REMARKS

In re Application of
Ulrich Braun
Application No.: 09/890,113
Filed: January 7, 2002
Page 19

PATENT
Attorney Docket No.: VOSS1170

Fig. 2

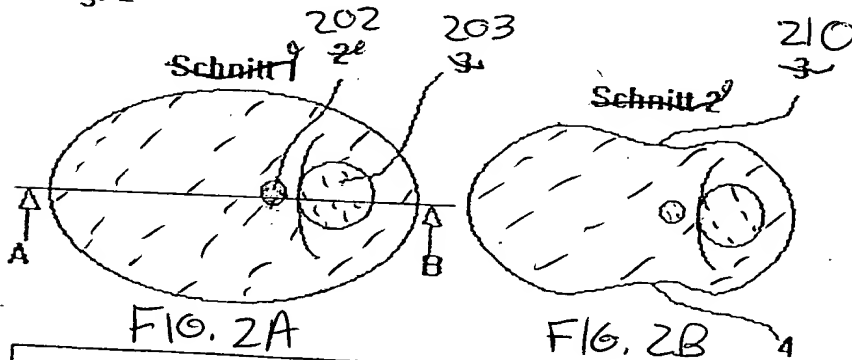
The Office Action objects to the drawings because allegedly proper drawing corrections were not submitted that include cross-hatching in Figures 1 and 2 (citing the requirement for red-lined drawings and a separate letter to the draftsman (MPEP 608.02 (r) and (v))). Furthermore, the Office Action alleges that the legends for Figs. 2A, 2B, 2C, 2D, and 3B are missing, and that reference numerals "2," "3" and "4" denote different elements between Figures 2 and 3, and that reference numeral "6" denotes different elements between Figures 1 and 3. 37 CFR §1.121, effective July 30, 2003, is silent with respect to providing red-lined sheets for a draftsman. It is also noteworthy that the requirement for annotated drawings is at the discretion of the Examiner.

Applicants have resubmitted replacement Figures 1 and 2A-2D with cross hatchings (Exhibit A). Furthermore, reference numerals "2," "3," "4," and "6" in Figures 1 and 2A-2B have been replaced with new numbers 202, 203, 204, and 210. An Annotated sheet showing the changes to the drawings has been submitted as Exhibit B. In addition, a red-lined sheet showing the changes in red ink is attached to the letter to the draftsman, filed herewith.

Regarding legends for Figures 2A, 2B, 2C, 2D, and 3B, the legends were provided on page 2 of the Response mailed April 24, 2003. These legends for the figures are found in paragraphs 24, 26-29, and 43. Accordingly, Applicants request withdrawal of the objection to the drawings.

With respect to "water free," FIGS. 2A-2D and amended paragraphs 9 and 10, which refer to the figures, disclose exemplary methods and device assemblies and designs for keeping the urine outlet water free.
